Welcome Break

Directional Signing for Motorway Services Proposals

Technical Note – Amendment with Additions Scenario

110705-PEF-XX-XX-TRP-H-000003

Ref	Approx Sign Location	New sign face	Intervention detail
PRMS01	M69 southbound 2 mile 2917.1		New sign assembly. New sign face and new post and foundation PRMS01.

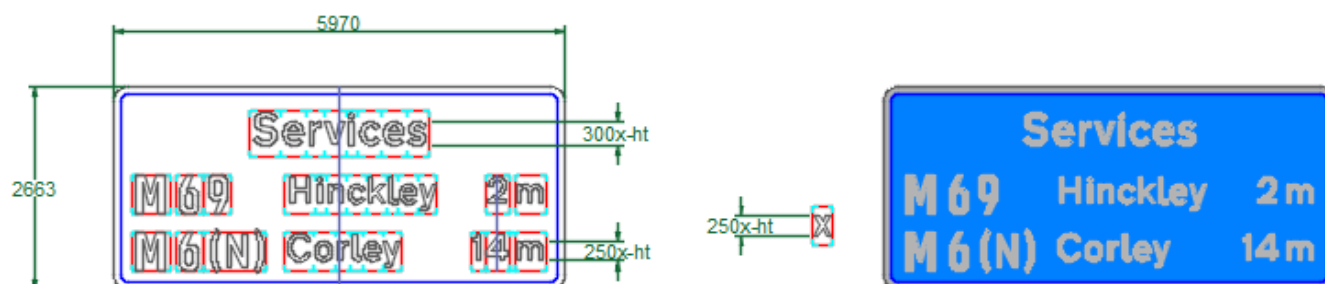
A new sign to dia. 2917.1 is required at approximately 2 miles from the exit datum.

The sign has been designed as per working drawing NP2917.1 to include the services geographical names and following all of the set-out rules from Ch7 with a main x-height of 250mm.

Ref	Approx Sign Location	New sign face	Intervention detail
PRMS02	M69 southbound 1 1/2 mile 2919.3		New sign assembly. New sign face and new posts and foundations PRMS02.

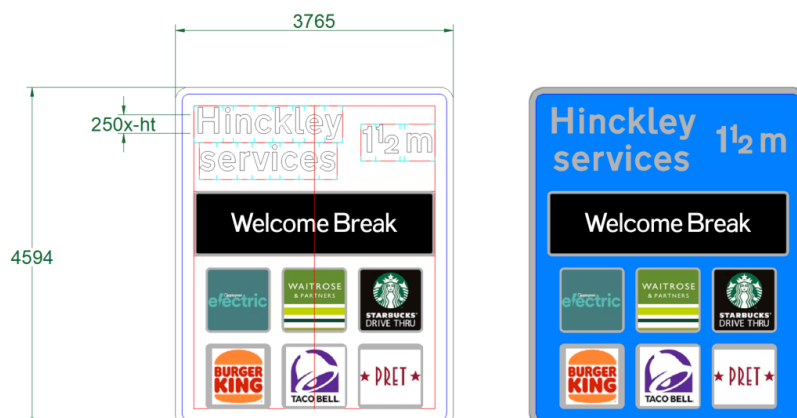
A new sign to dia. 2917.1 is required at approximately one and a half miles from the exit datum. The sign has been designed with a main x-height of 250mm.

Corporate identifiers of operators at the site to be confirmed. Where a specific fuel provider cannot be identified, the first corporate identifier should be substituted with the “Fuel” pump symbol from TSRGD S12-24-8.

Ref	Approx Sign Location	New sign face	Intervention detail
PRMS03	M69 southbound Located 200m downstream of existing 1/2 mile Secondary ADS		New sign assembly. New sign face and new posts and foundations PRMS03.

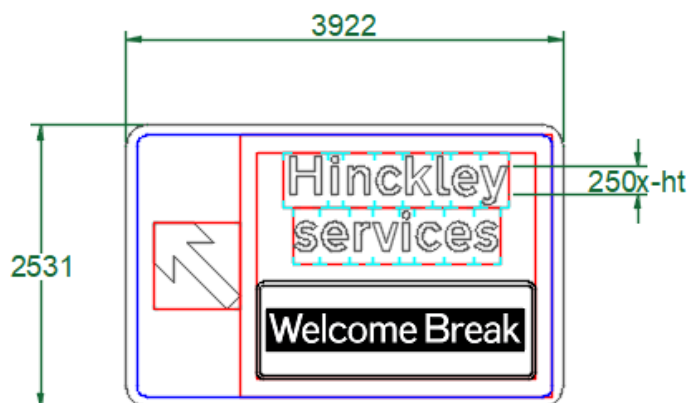
A new final direction sign is required at approximately 600m from the exit datum. The sign has been designed with a main x-height of 250mm.

Ref	Approx Sign Location	New sign face	Intervention detail
PRMS04	M69 northbound 2 mile 2917.1		New sign assembly. New sign face and new post and foundation PRMS04.

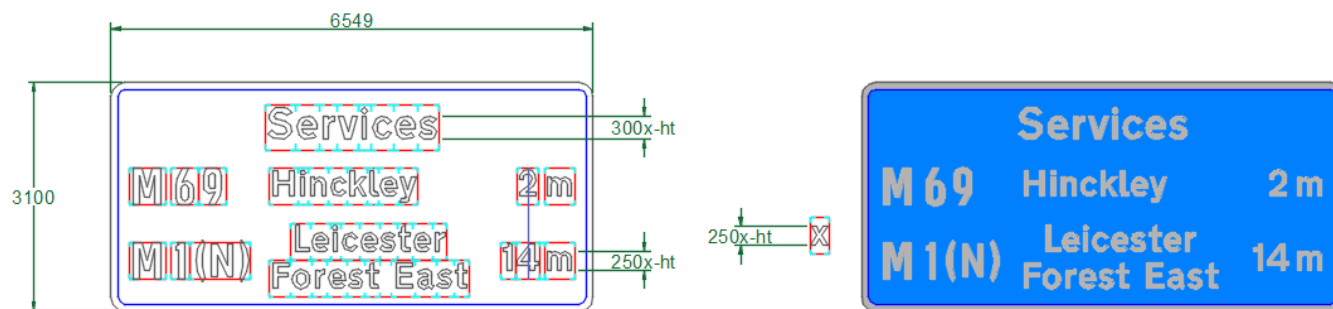
A new sign to dia. 2917.1 is required at approximately 2 miles from the exit datum.

The sign has been designed as per working drawing NP2917.1 to include the services geographical names and following all of the set-out rules from Ch7 with a main x-height of 250mm.

Ref	Approx Sign Location	New sign face	Intervention detail
PRMS05	M69 northbound 1 1/2 mile 2919.3		New sign assembly. New sign face and new posts and foundations PRMS05.

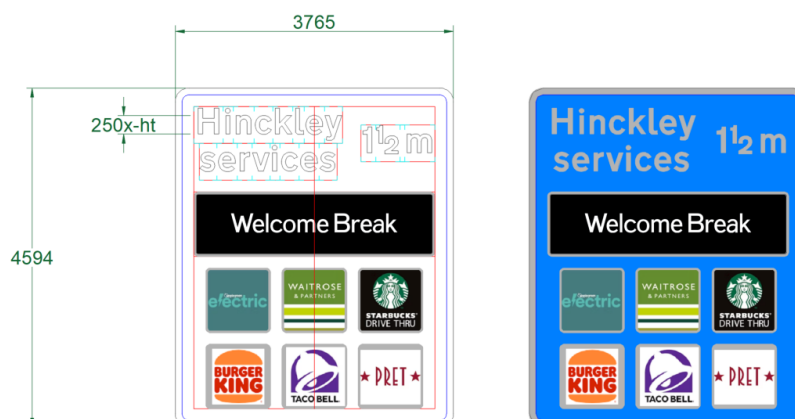
A new sign to dia. 2917.1 is required at approximately one and a half miles from the exit datum. The sign has been designed with a main x-height of 250mm.

Corporate identifiers of operators at the site to be confirmed. Where a specific fuel provider cannot be identified, the first corporate identifier should be substituted with the “Fuel” pump symbol from TSRGD S12-24-8.

Ref	Approx Sign Location	New sign face	Intervention detail
PRMS06	M69 northbound Located 200m downstream of existing 1/2 mile Secondary ADS		New sign assembly. New sign face and new posts and foundations PRMS06.

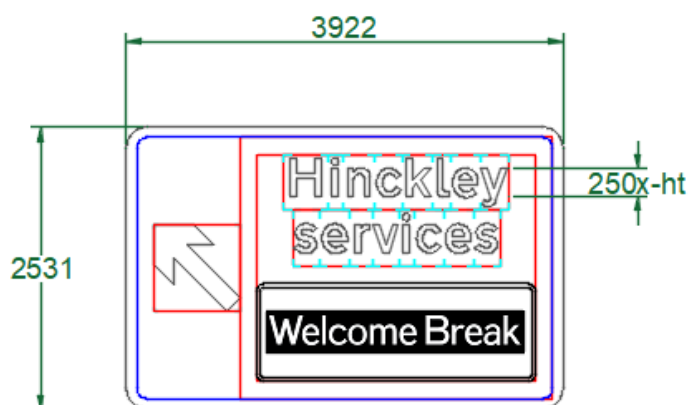
A new final direction sign is required at approximately 600m from the exit datum. The sign has been designed with a main x-height of 250mm.

Ref	Approx Sign Location	Google Streetview Capture	Intervention detail
EXMS 17	M69 southbound Confirmatory DS		Replace full sign assembly. New sign face and new post and foundation PRMS07.

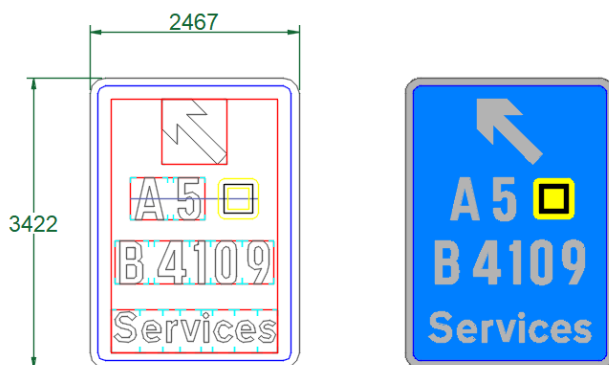
The existing sign assembly located on the nose of the junction exit shows only the A5 route number.

The proposed new sign will need to incorporate the legend “Services” as well as the currently shown “A5”.

The upstream ADS signage also indicates route “B4109” together with a tactical diversion symbol [open square].

The proposed new sign PRMS07 has therefore been designed following all of the set-out rules from Ch7 with an x-height of 250mm (refer to TSM Ch7 Appendix E - row 7, column 7, lower value).

For fullness and route continuity the proposals correct the current omissions and errors however this results in the sign overall dimensions significantly increasing over the existing sign which this would replace.

The proposed sign dimensions should be such that it can be satisfactorily mounted on a single signpost. There is existing VRS in this location. A new assembly would not require a passively safe structure however good practice would be to specify passively safe posts regardless.

A replacement post will very likely be installed outside of the VRS working width as is the case with the existing assembly. There is however a likelihood that the replacement sign face (being substantially larger than the sign it is to replace) may encroach into the VRS working width. There may be potential for a large vehicle (such as HGV or bus) to strike the sign face as the VRS yields if involved in a collision with the VRS. This may be mitigated through the use of a GRP sign substrate in this location.

Ref	Approx Sign Location	Google Streetview Capture	Intervention detail
EXMS23	M69 northbound Confirmatory DS		Replace sign assembly. New sign face and new post and foundation PRMS08.

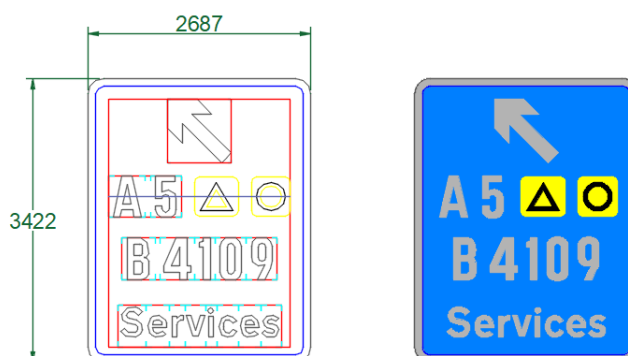
The existing sign assembly located on the nose of the junction exit shows only the A5 route number.

The proposed sign will need to incorporate the legend “Services” as well as the currently shown “A5”.

The upstream ADS signage also indicates route “B4109” together with two tactical diversion symbols [open triangle] [open circle].

The proposed new sign PRMS08 has therefore been designed following all of the set-out rules from Ch7 with an x-height of 250mm (refer to TSM Ch7 Appendix E - row 7, column 7, lower value).

For fullness and route continuity the proposals correct the current omissions and errors however this results in the sign overall dimensions significantly increasing over the existing sign which this would replace.

The proposed sign dimensions should be such that it can be satisfactorily mounted on a single signpost. There is existing VRS in this location. A new assembly would not require a passively safe structure however good practice would be to specify passively safe posts regardless.

A replacement post will very likely be installed outside of the VRS working width as is the case with the existing assembly. There is however a likelihood that the replacement sign face (being substantially larger than the sign it is to replace) may encroach into the VRS working width. There may be potential for a large vehicle (such as HGV or bus) to strike the sign face as the VRS yields if involved in a collision with the VRS. This may be mitigated through the use of a GRP sign substrate in this location.

It is noted that the existing roundabout ADS sign (EXLS9 to be replaced by PRLS06) on this approach displays 3 tactical diversion symbols ('filled circle', 'open square', and 'open triangle'). This is not consistent with the upstream mainline ADSs however (which indicate only 'open square'). There is however a “secret sign” located approximately 50m upstream

of the '100 yards' countdown marker and this may display other tactical diversion information including 'filled circle', and 'open triangle' routes to be followed.

NH should confirm the current tactical diversion routes signed on approach to this diverge and confirm what symbols are to be included on the proposed replacement sign.

Ref	Approx Sign Location	Google Streetview Capture	Intervention detail
EXMS18	M69 northbound Services DS		Replace sign assembly. New sign face and new post and foundation PRMS09.

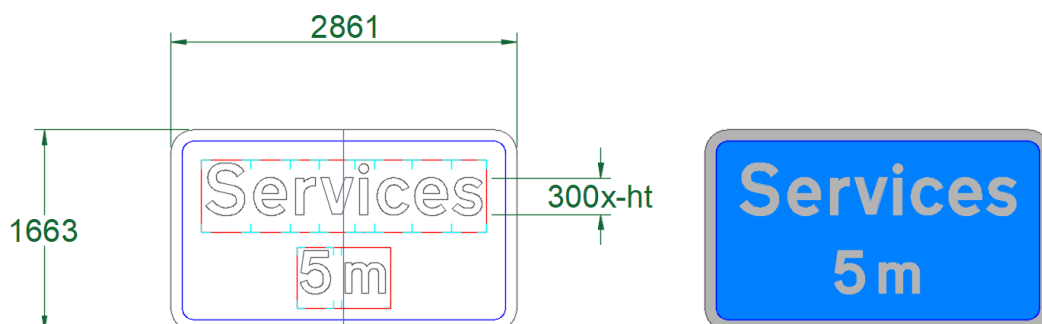
There is an existing sign facing northbound traffic on the M69 just downstream of its junction with the M6 / A46.

The sign does not conform to TSRGD and the displayed reference to services on the “M1(Northbound) 17m” would no longer be relevant as the new MSA at Hinckley could be reached and accessed prior to those signed services [Leicester Forest East].

At each point of entry to the motorway network, where space permits, a sign to diagram 2918 should be provided, indicating the distance to the next MSA along that motorway.

This type of sign is normally located 200m downstream of the Route Confirmatory sign.

The sign should display the distance to the next services which would be Hinckley at a distance of 5 miles (actual 5.3 miles rounded down to nearest).

The sign should therefore be replaced with a new assembly sign to dia. 2918.

Ref	Approx Sign Location	Google Streetview Capture	Intervention detail
EXMS17	M6 southeast bound Located between J3 and J2.		Replace sign assembly. New sign face and new post and foundation PRMS10.

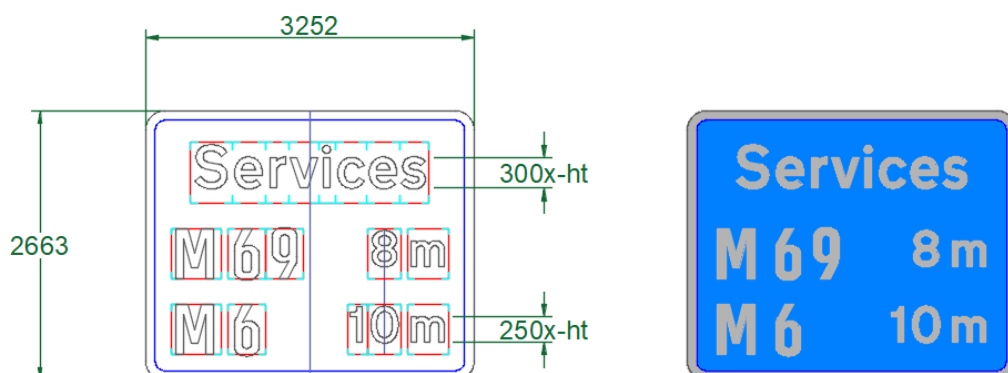
There is an existing sign facing southeast bound traffic on the M6, upstream of its junction with the M69 / A46.

The sign does not conform to TSRGD and the displayed reference to the services on the “M1(N) 18m” and “M1(S) 20” would no longer be relevant as both the new MSA at Hinckley (to be located off M69 J1) and the recently constructed existing services at Rugby (M6 J1) are reached and accessed prior to those currently signed services [Leicester Forest East and Watford Gap].

The reference to services on M1(N) would no longer be relevant on a sign in this location as the new services at Hinckley would be reached prior reaching the displayed services “M1(N)” [Leicester Forest East].

Similarly, the reference to services on M1(S) would no longer be relevant on a sign in this location as the new services at Rugby would be reached prior reaching the displayed services “M1(S)” [Watford Gap].

The existing sign does not conform to TSRGD as the distances do not have the “m” suffix. Unlike route confirmatory signs which do not have the “m” suffix, signs to dia. 2917.1 should have this.

The sign should have been amended upon the opening of the MSA at Rugby. It may be prudent therefore to reach an agreement with National Highways for the full replacement of this assembly at shared cost.

Ref	Approx Sign Location	Google Streetview Capture	Intervention detail
EXMS1	M1 south bound Approach to Leicester Forest East MSA at 2 miles.		Replace sign assembly. New sign face and new post and foundation PRMS11.

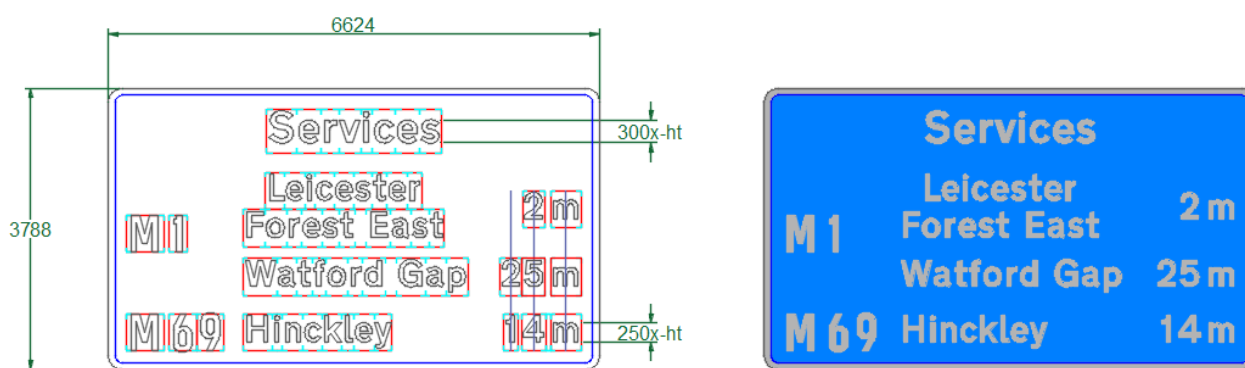
There is an existing sign facing south bound traffic on the M1 upstream of its junction with the M1 / A46 located approximately 2 miles in advance on approach to Leicester Forest East MSA.

The sign is the older variant (dia. 2917) with owner operator details shown on the face. The existing displayed reference to next services on M6(N) would no longer be relevant on a sign in this location as the new services at Hinckley would be reached prior reaching the displayed services “M6(N) Welcome Break” [Corley].

National Highways have expressed concern over the sign being currently mounted at a height lower than would be expected.

The sign should therefore be replaced with a new assembly sign to dia. 2917.1.

Ref	Approx Sign Location	Google Streetview Capture	Intervention detail
EXMS14	M6 east bound Approach to Corley MSA at 1 mile		Replace sign face. New sign face and new post and foundation PRMS12.

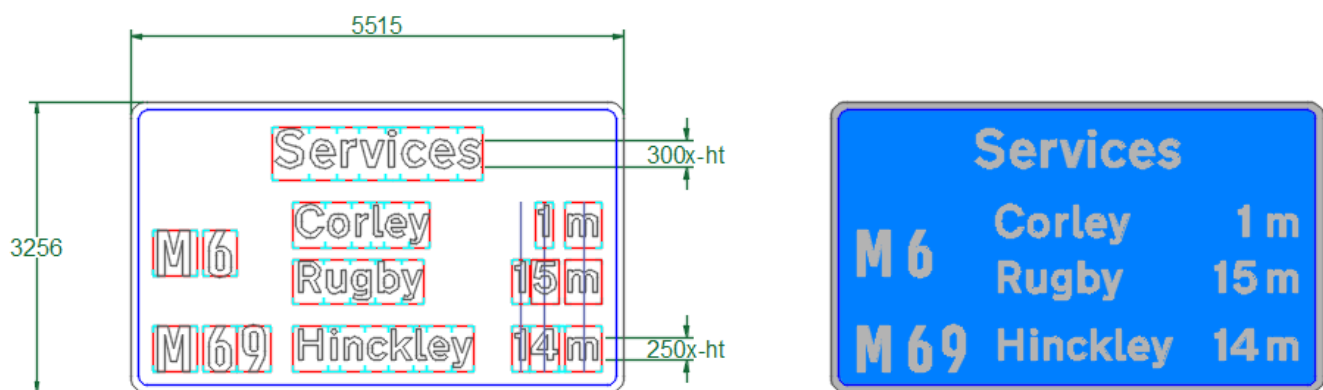
There is an existing sign facing southeast bound traffic on the M6 located approximately 1 mile upstream of Corley MSA.

The sign is the older variant (dia. 2917) with owner operator details shown on the face. The existing displayed references to next services on M1(N) and M1(S) would no longer be relevant on a sign in this location.

The proposed new services at Hinckley (off M69 J1) would be reached prior to the displayed services “M1(N) Welcome Break KFC” [Leicester Forest]. Likewise, the services at Rugby (off M6 J1) would be reached prior to the displayed services “M1(S) McDonalds Costa” [Watford Gap].

Subject to the agreement and approval by National Highways it may be possible to provide this replacement sign face and reuse part of the existing post arrangement. Contingent upon confirmation, an assessment of the existing signposts may determine whether a replacement sign face can be accommodated within the capacity of the existing post load. The existing sign is currently mounted on a 5 post assembly.

The sign should therefore be replaced with a new assembly sign to dia. 2917.1.

Full New assembly PRMS13;

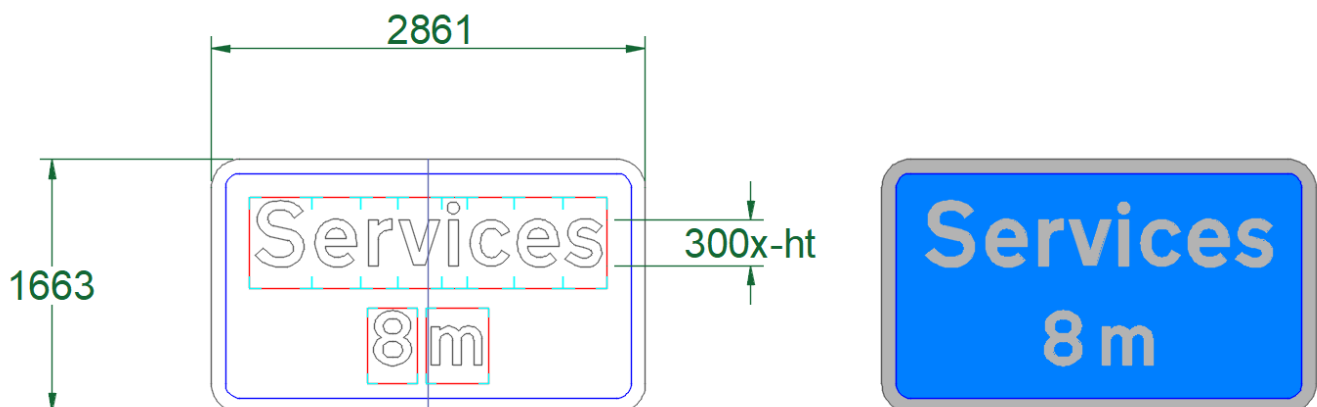
There is no sign currently in place on the M69 just downstream of its junction with the M1 / A5460 to provide drivers with information relating to the distance to next motorway services.

At each point of entry to the motorway network, where space permits, a sign to diagram 2918 should be provided, indicating the distance to the next MSA along that motorway.

This type of sign is normally located 200m downstream of the Route Confirmatory sign (existing sign image grab from Google with point approx. 200m downstream).

A new sign of this type should display the distance to the next services which would be Hinckley, at a distance of 8 miles (actual 8.4 miles rounded down to nearest mile).

There is no existing VRS at the point 200m downstream of the existing Route Confirmatory sign. A new assembly would require a passively safe structure.

A new sign should be installed to dia. 2918.

Ref	Approx Sign Location	New sign face	Intervention detail
PRLS01 (EXLS15)	A5 southbound approach to roundabout. To replace the existing sign assembly outside Miller and Carter Steakhouse.		New sign assembly. New sign face and new post/s and foundations PRLS01.

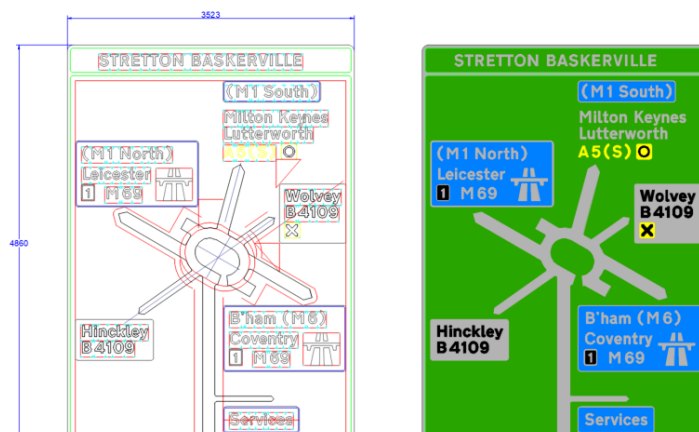
A sign indicating the route to the new MSA should be provided on all-purpose trunk road (APTR) network. Where “Services” or “Geographical name services” is incorporated into a directional sign this should be in a blue panel.

It is proposed to install a full new sign assembly to replace the existing ADS sign assembly located outside the Miller and Carter Steakhouse.

The posted speed limit on A5 Watling Street travelling eastbound (from the roundabout at Logix Park) on approach to the site is 40mph. An x-height of 100mm would therefore be appropriate for this sign. (refer to TSM Ch7 Appendix E – row 3, column 3, lower value). The existing sign face to be replaced has an x-height of 100mm.

A replacement of this sign will also provide opportunity to correct existing errors with regard to the incorporated tactical diversion symbols. The tactical diversion symbols should be associated with the relevant route number to be followed and where applicable contained within the relevant panel.

It would be recommended that the new sign be mounted on a passively safe posts given the likely 85th percentile vehicle speed in both directions at this location being at or around 40mph. There is no existing VRS in this location.

Ref	Approx Sign Location	New sign face	Intervention detail
PRLS02 (EXLS4)	A5 westbound approach to roundabout.		New sign assembly. New sign face and new post/s and foundations PRLS02.

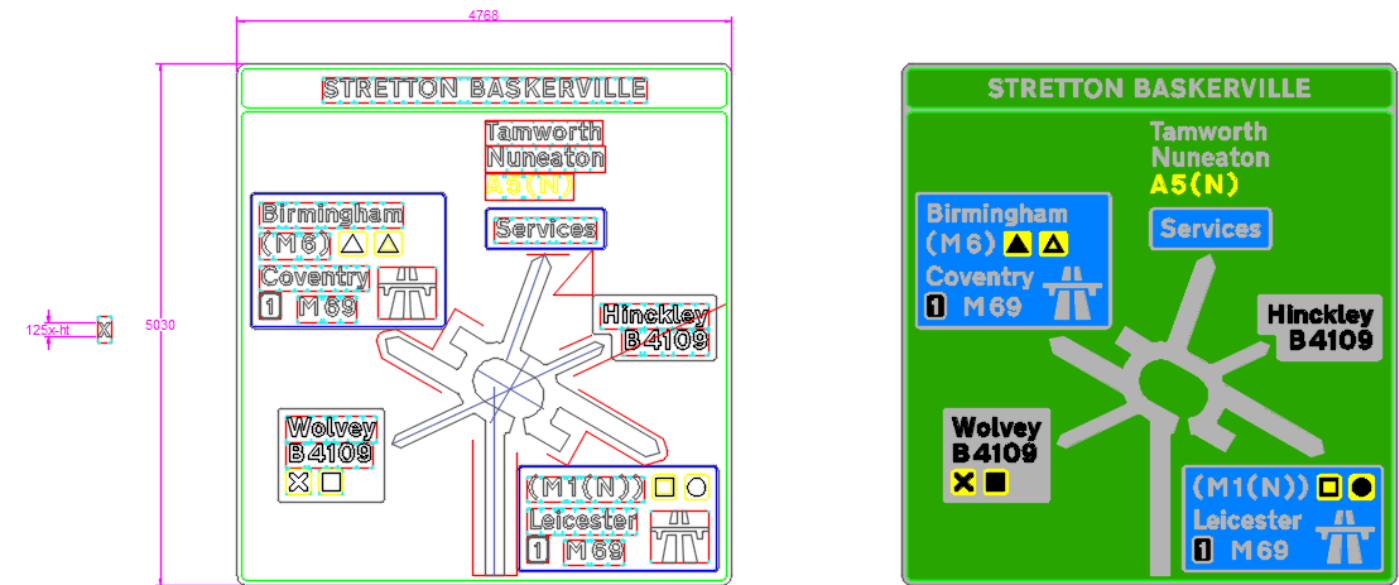
A new replacement ADS sign is proposed to replace EXLS4 to incorporate the legend “Services” on blue panel and to direct drivers to the new service area at Hinckley from the roundabout via the westbound A5 exit from the roundabout.

It is proposed to install a full new sign assembly to replace the existing ADS sign assembly located opposite Hinkley Island Leonardo Hotel.

An assessment of the existing sign assumes that the sign has been designed following most of the set-out rules from TSM Ch7 with an x-height of 125mm (appropriate lower value for an 85th percentile approach speed between 41 and 50mph).

A replacement of this sign will also provide opportunity to correct existing errors with regard to the incorporated tactical diversion symbols. The tactical diversion symbols should be associated with the relevant route number to be followed and contained within the relevant panel.

The destinations reached via the first downstream exit are not currently included on the sign face. The addition of a suitable route arm and destination block panel will aid approaching drivers in better understanding the road layout ahead and using the roundabout more safely. This will also improve legibility of the tactical diversion symbols associated with this route.

Ref	Approx Sign Location	New sign face	Intervention detail
PRLS03 EXLS1	M69 northbound Exit slip road primary ADS		New sign face mount on existing post/s PRLS03

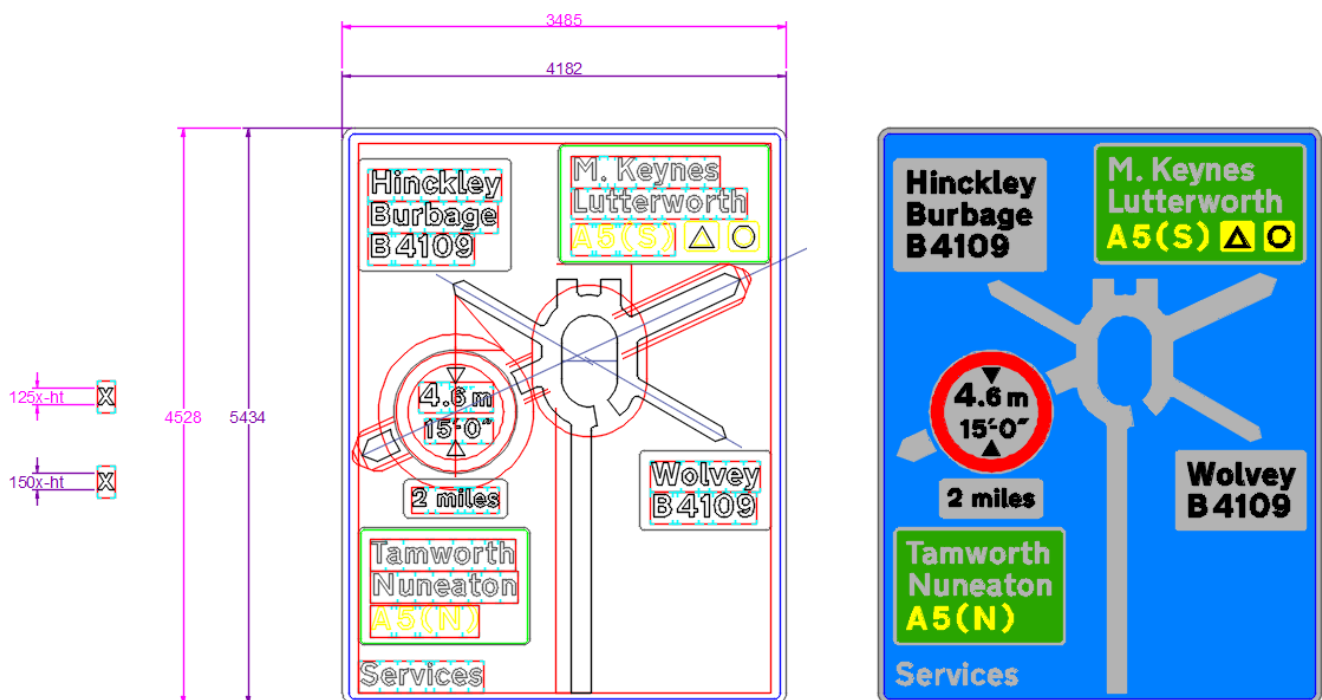
A new replacement ADS sign face is proposed to replace EXLS1 to incorporate the legend “Services” and to direct drivers to the new service area at Hinckley from the roundabout.

Where “Services” or “Geographical name services” is incorporated into a motorway slip road advance directional sign this should be in white on the main blue background of the sign.

It is proposed to install a new sign face to replace the existing ADS onto the existing 3no. Lattix posts. The new sign face layout design should be such that the proposed overall area of the sign face does not exceed the existing sign dimensions so that no additional load will be exerted on the post and foundation assembly, thereby negating the need to fully replace.

The slip road is national speed limit on approach to the roundabout. An x-height of 150mm would be more appropriate for this sign on the assumption that the likely 85th percentile vehicle speed on approach to the sign is at or between 51 and 60 mph given road geometry and expectation of drivers slowing having exited the motorway main alignment (refer to TSM Ch7 Appendix E – row 5, column 3, lower value). Contingent upon confirmation, the existing sign proportions suggest an x-ht of 125mm has been used on the existing sign face however.
